Starting and Charging: All Technical Service Bulletins Campaign - Electrical Center Battery Stud

Number: 94-C-59

PRODUCT CAMPAIGN 94-C-59 - ELECTRICAL CENTER BATTERY STUD

1994 CHEVROLET CAPRICE SEO VEHICLES (POLICE CARS, TAXI AND SPECIAL SERVICE WAGONS)

FIGURE 1

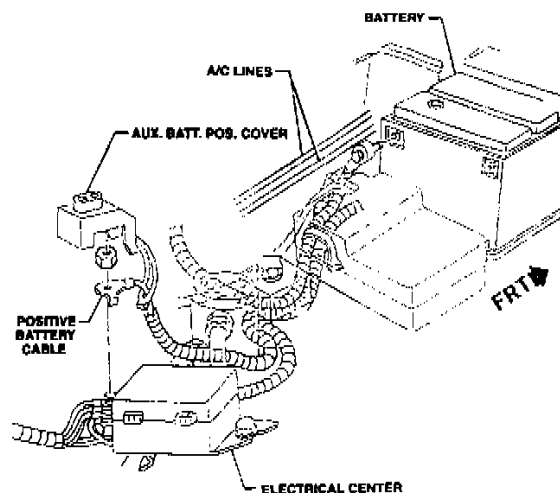
2. Remove "AUX. BATT. POS. COVER" (Figure 1) from electrical center stud. Electrical center and stud is located on top of right hand wheelhouse, just ahead of front of dash.
3. Remove stud nut (not to be reinstalled) and positive battery cable from stud (Figure 1).
4. Remove two nuts holding electrical center to wheelhouse.
5. Remove top cover from electrical center.

FIGURE 2

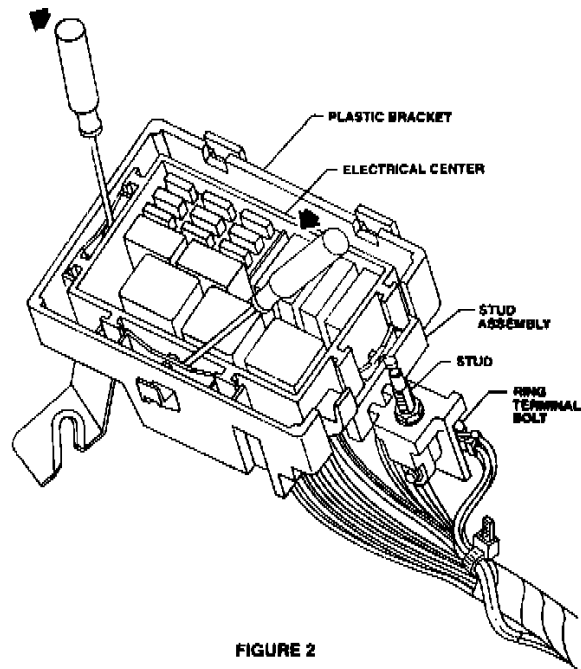
6. Remove electrical center from plastic bracket. Use a small screwdriver to release retaining tabs (Figure 2).

FIGURE 3

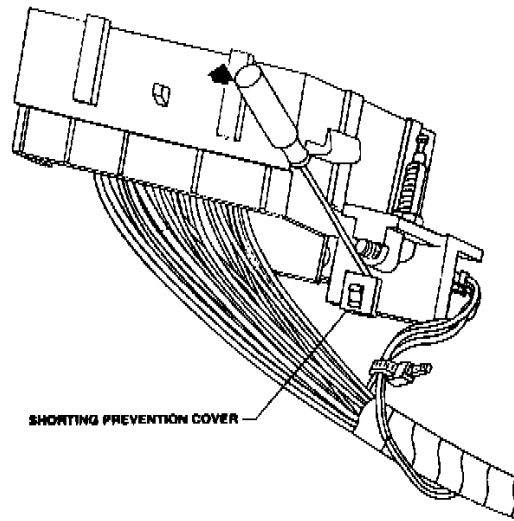
7. Remove small shorting prevention cover from lower portion of stud assembly (Figure 3).
8. Remove bolt securing ring terminals to bottom portion of stud assembly (Figure 2).
9. Remove 4 large Maxi-fuses.

FIGURE 4

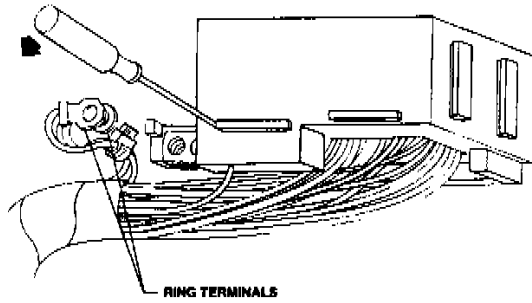
10. Remove Terminal Position Assurance "TPA" closest to stud (Figure 4).

FIGURE 5

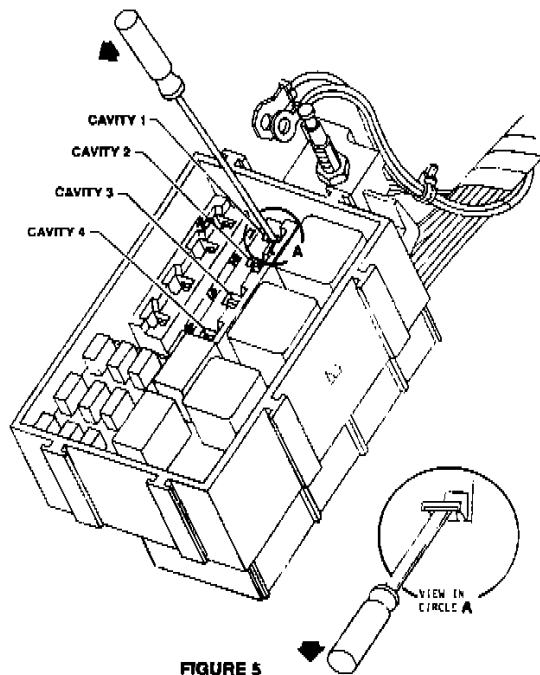
11. Use a small flat blade screwdriver to release the four terminals securing the two bussbars in electrical center (see Figure 5) Pull bussbar out the bottom.

FIGURE 6

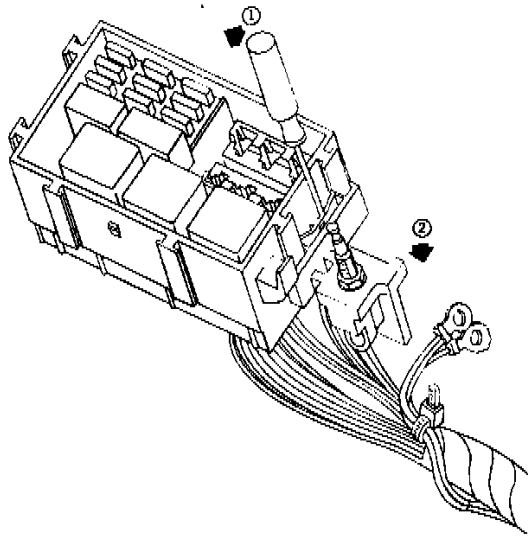
12. Release retaining tab, then slide stud assembly from electrical center (Figure 6).
13. Install new stud assembly to electrical center.
14. Reinstall bussbars. Make certain bussbars are not damaged, and click them firmly into place. If bussbars are damaged, replacement is required.
